TECHNICAL SERVICE BULLETIN

TSB#: 16-013

Inspect the battery disconnect switch to confirm it is working properly.
Correct wiring to battery disconnect switch when required.

2016 Eagle Fifth Wheels

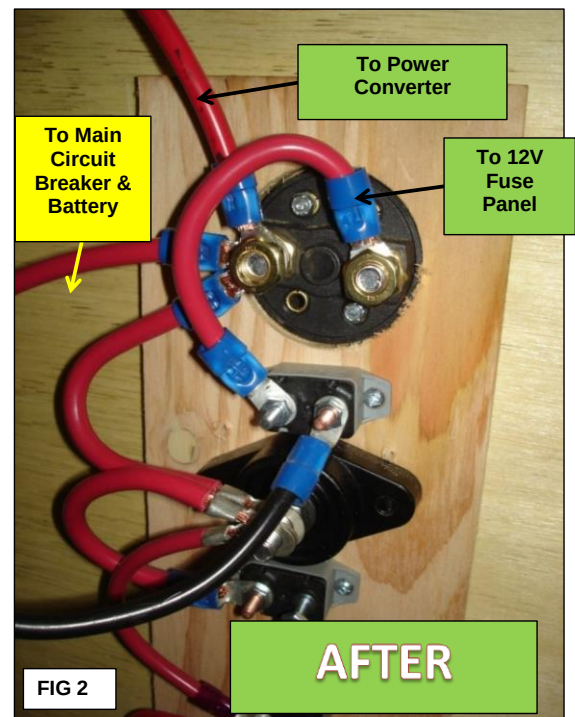
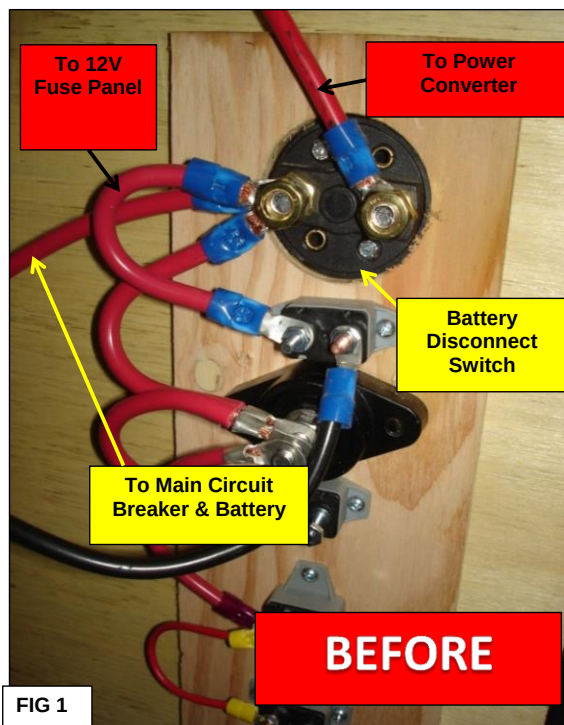
- Fig 1:** Remove nuts from the terminals of the battery disconnect switch and wire for the Power Converter and wire for the 12V Fuse Panel.
- Fig 2:** Reverse the Power Converter wire and the 12V Fuse Panel wire on the battery disconnect switch - tighten with nuts.

(Refer to the schematics on Page 2)

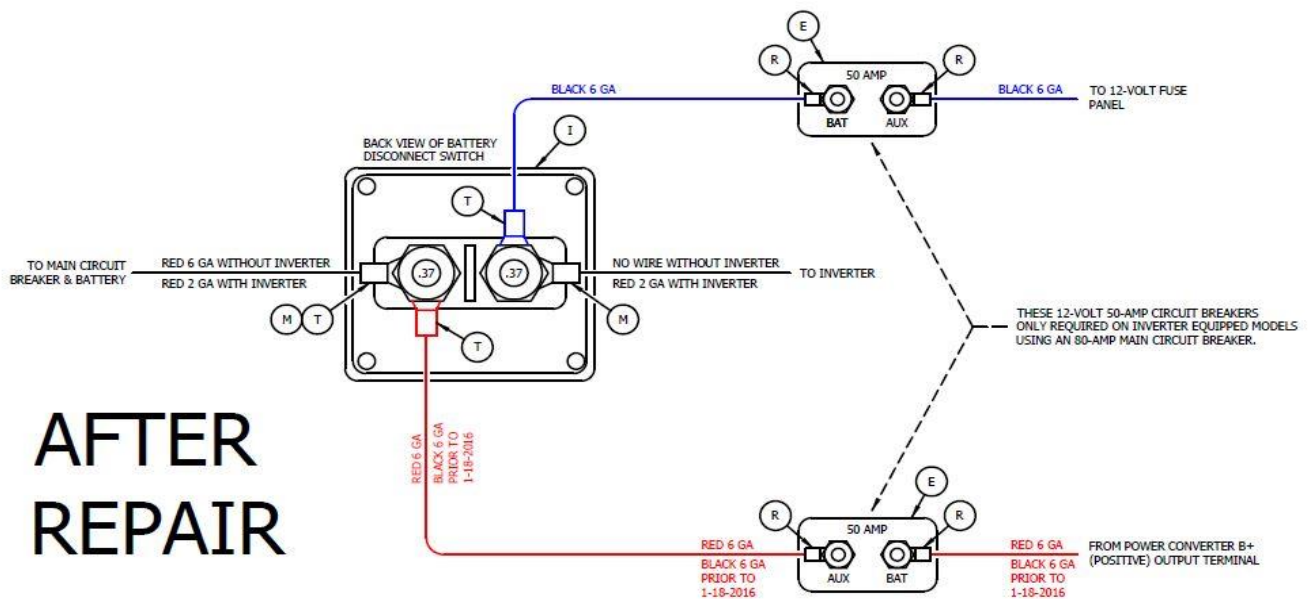
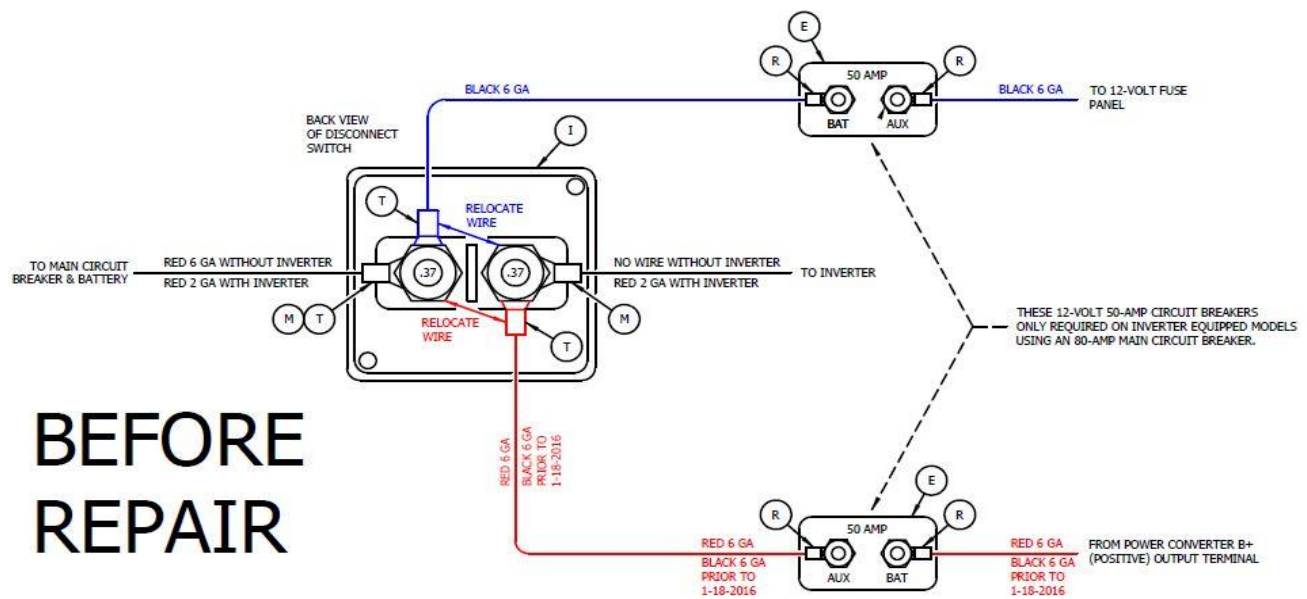
Jayco has determined that certain Model Year 2016 Eagle Fifth Wheels require inspection of the battery disconnect switch to ensure it is working properly. If not, the power converter wire and the 12V fuse panel wire on the switch are reversed and must be corrected.
